# Swimming and spa pool fencing

## Inspection form

23 Wapiti Avenue  
Epsom

## Site sketch

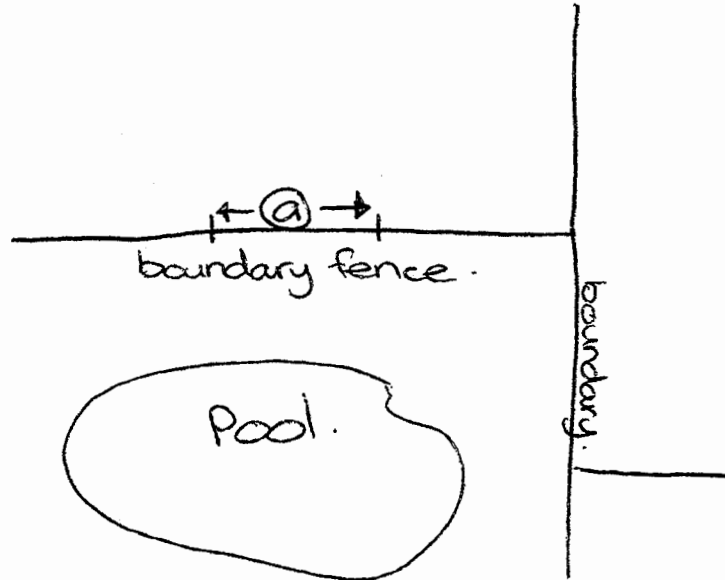
① trellis on neighbours side of boundary fence exceeds the 50mm maximum allowed & is therefore deemed climbable, I suggest talking with your neighbour to either remove or cover with a non-climbable material to a height of 1.2M. Alternatively isolate the fencing.
